Product Change Notification (PCN)

PCN Number	506362	Date Issued	January 17, 2019
Reason for Change	Capacity change or tool replacement		
Change Type Description	This letter is to inform you that another set of tooling is being added to meet the current and future demands of this product. There will be no changes in the fit, form or function from the additional tooling when compared to the current tooling.		
Reason for Short Notice	New Capacity		
Assessment of Change	Product will be fully qualified before it is shipped. Qualification reports are available upon request.		
Internal Molex Qualification Date	December 07, 2018		
Sample Availability Date (Changed Part)	December 07, 2018		
Planned Implementation Date	February 17, 2019		
Method of Identifying Change	Lot information on label

CMC 48way explode view

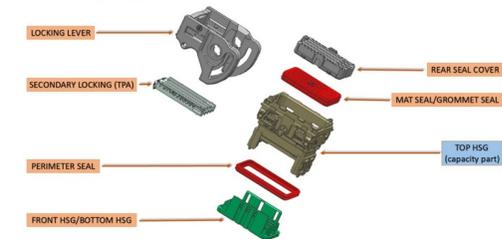
- New capacity tooling of 48w rcpt housing top part(P/N 98993-0311) is being fabricated in Molex Chengdu to increase capacity of CMC 48w receptacle series in order to support increased demand
- Product Impact
No impact, state "no impact to fit, form or function"
- Part Number Impact
989930311
- PPAP and samples available upon request
